**WOODBIDGE SCHOOL DISTRICT  
New Woodbridge High School  
Bid Pac C**

ADDENDUM NO. 2

04 June 2013

ARCHITECT'S PROJECT NO: 11109

DWN BY: CLJ	CHK BY: CDH	PROJ. NUMBER: 11156C
DATE: 04-15-13	DRAWING NUMBER:	E30-21 BID PACK C
SCALE: AS NOTED

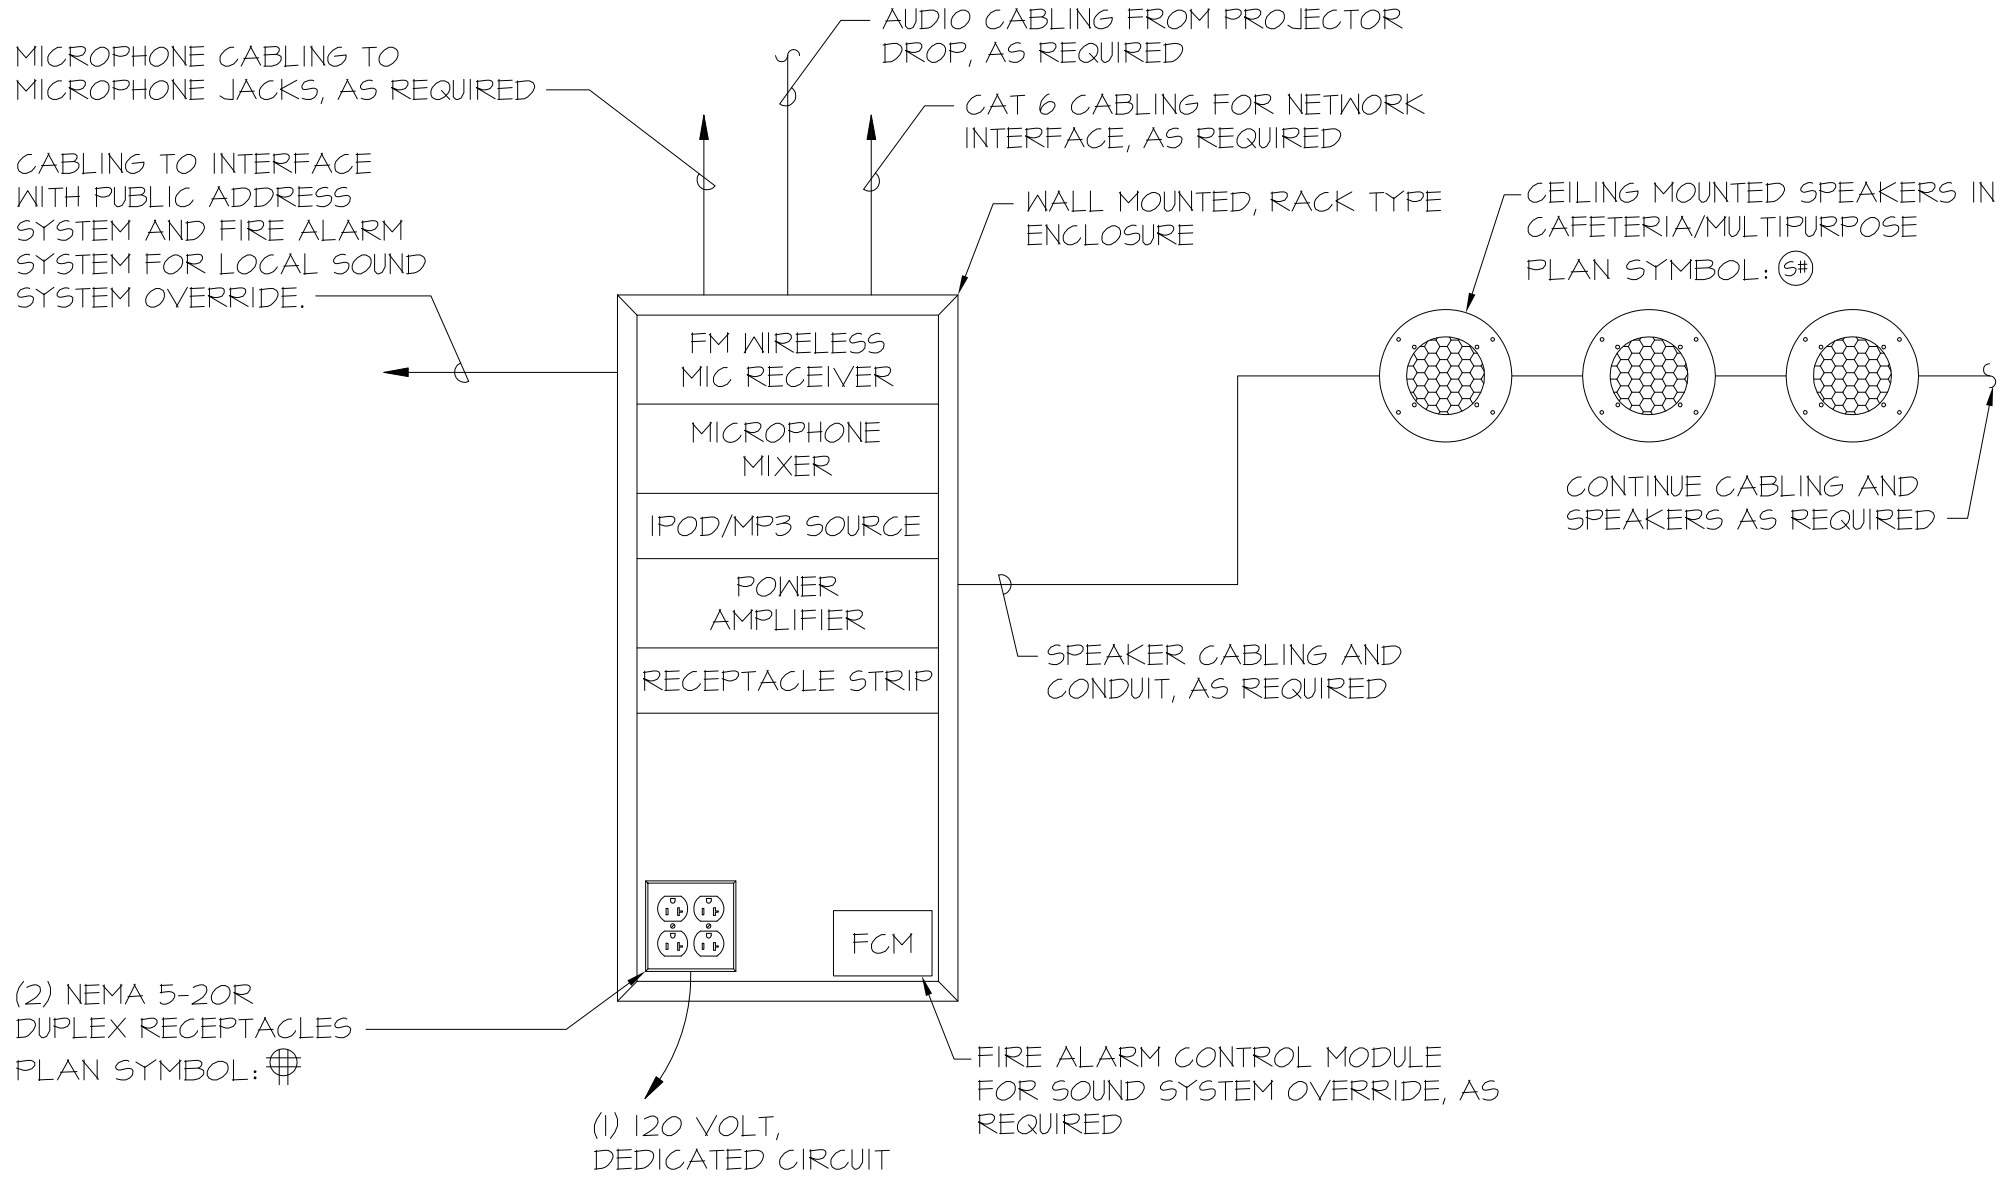
- Q4. Reference Spec 275115-2, Description of Work 1.3A. A reference is made to 'plans' for the gym and cafeteria sound systems. There are no audio system block diagrams for these spaces in Bid Pack C.

3.1 INSERT Drawing E30-21 Details – Electrical Local Gymnasium Sound System Diagram and Local Cafeteria/Multipurpose Sound System Diagram into the Contract Documents.

ADD LOCAL SOUND SYSTEM DIAGRAMS FOR GYMNASIUM AND CAFETERIA.

- A4. Refer to electrical sketches issued under Addendum #2.**
- Q5. Who is responsible for installing the Smart Boards and their projectors?
- A5. Refer to EDiS's Summary of Work issued under Bid Pack "C" for additional information.**

1. PROVIDE PROVISIONS TO INTERFACE WITH PORTABLE ASSISTED LISTENING SYSTEM.

1. PROVIDE PROVISIONS TO INTERFACE WITH PORTABLE ASSISTED LISTENING SYSTEM.
